Technical Service Bulletin (TSB)
Flash: Motor Control Processor A (MCP A) Updates 6A1

REFERENCE:	TSB: 08-027-25 REV. B GROUP: 08 - Electrical	Date:	April 29, 2025	REVISION:	08-027-25 REV. A
VEHICLES AFFECTED:	2025 (LB) Dodge Charger This bulletin applies to vehicles built on or before **April 03, 2025 (MDH 0403XX)** equipped with 400V G2500 FR/RR Elec Drive Motors (Sales Code ELD).			MARKET APPLICABILITY:	
				<input checked="" type="checkbox"/> NA	<input checked="" type="checkbox"/> MEA
				<input checked="" type="checkbox"/> SA	<input checked="" type="checkbox"/> IAP
				<input checked="" type="checkbox"/> EE	<input checked="" type="checkbox"/> CH
CUSTOMER SYMPTOM:	Customers must experience a Malfunction Indicator Lamp (MIL) illumination and the vehicle must exhibit/set the following Diagnostic Trouble Code (DTC): <ul style="list-style-type: none"> • P1626-00 - Park Pawl Motor Stuck. The customer may comment on one or more of the following symptoms: <ul style="list-style-type: none"> • Wrench icon is illuminated on the Instrument Panel Cluster (IPC). • Turtle icon illuminated on the IPC. • Reduced power. • Vehicle will not shift out of park.

This bulletin supersedes Technical S

Fig. 1
Cooling Fan Assembly

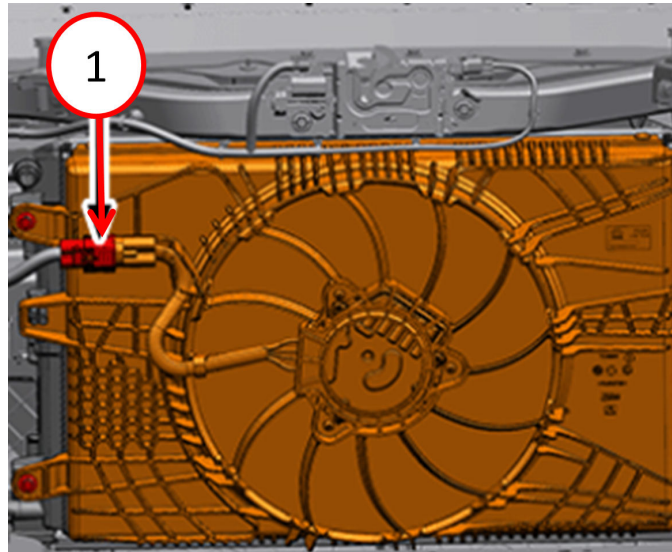
4. Disconnect the cooling fan wire harness connector [Fig. 1](#).

Fig. 3
#38 AGSM Fuse Location

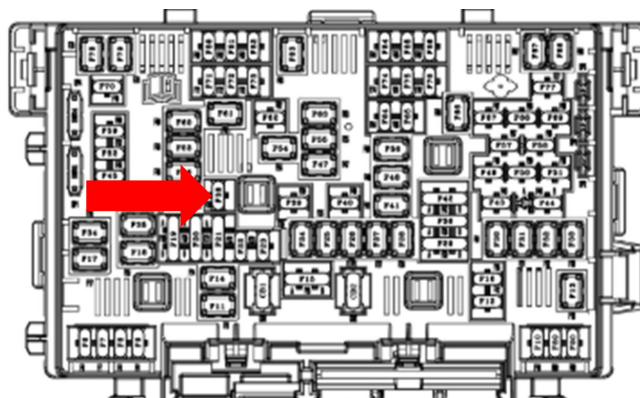
6. Remove the PDC cover, locate and remove the #38 AGSM fuse [Fig. 3](#).**
